Our Ref: 26001.L01.001
BCC Ref: A006981928

RE: RESPONSE TO INFORMATION REQUEST UNDER PART 3 OF DEVELOPMENT ASSESSMENT RULES UNDER SECTION 68(1) OF PLANNING ACT 2016 – DEVELOPMENT APPLICATION ON LAND LOCATED AT 84 WALLACE ST CHERMSIDE.

NB - Existing approval outlined in red.

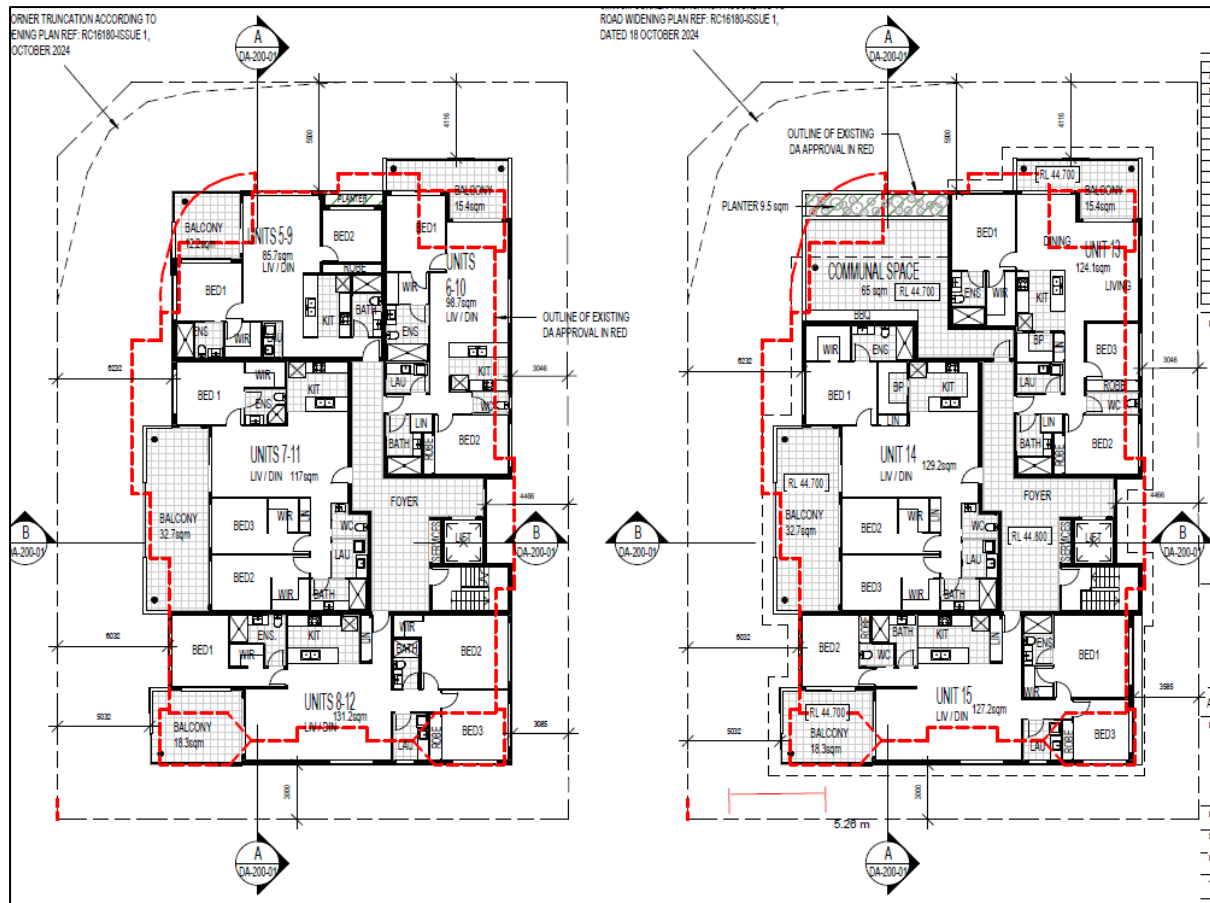
1. *The proposed site cover for the proposed development is considered to be excessive, which results in poor landscaping outcomes and will impact the amenity of future occupants and adjoining properties.*
 - a. *To address PO8 of the Multiple dwelling code, design changes are required to facilitate a balance of building to open space and landscaping on the site. This includes amendments to side boundary setbacks and communal open space as discussed below.*

2. *The proposed side boundary setbacks of 3m is insufficient to support the separation of buildings and provide visual and acoustic privacy without the reliance of screening and therefore, inconsistent with PO3 and PO7 of the Multiple dwelling code.*
 - a. *Provide amended plans to increase side boundary setbacks along the eastern and southern side boundaries to closely align with the average setbacks as defined in AO7.1 of the Multiple dwelling codes.*

RESPONSE: The updated design reduces site coverage and increases the setbacks in areas. The pedestrian entrance has been widened and the overall landscaped area has been expanded.

As per the above extracts the bulk & scale of the development remains consistent with the existing approved building design. Refer to **Revised Plans attached in in Appendix A.**

RESPONSE: As demonstrated in the extracts above and below, the proposed building setbacks remain fundamentally consistent with the existing approved layout. Openings along both side boundaries are restricted to high-level glazing or fitted with appropriate screening mechanisms, thereby ensuring that the acoustic and visual privacy of adjoining residents is preserved. Furthermore, the communal open space is positioned at the street corner, isolated from adjoining residential boundaries to mitigate potential acoustic impacts.
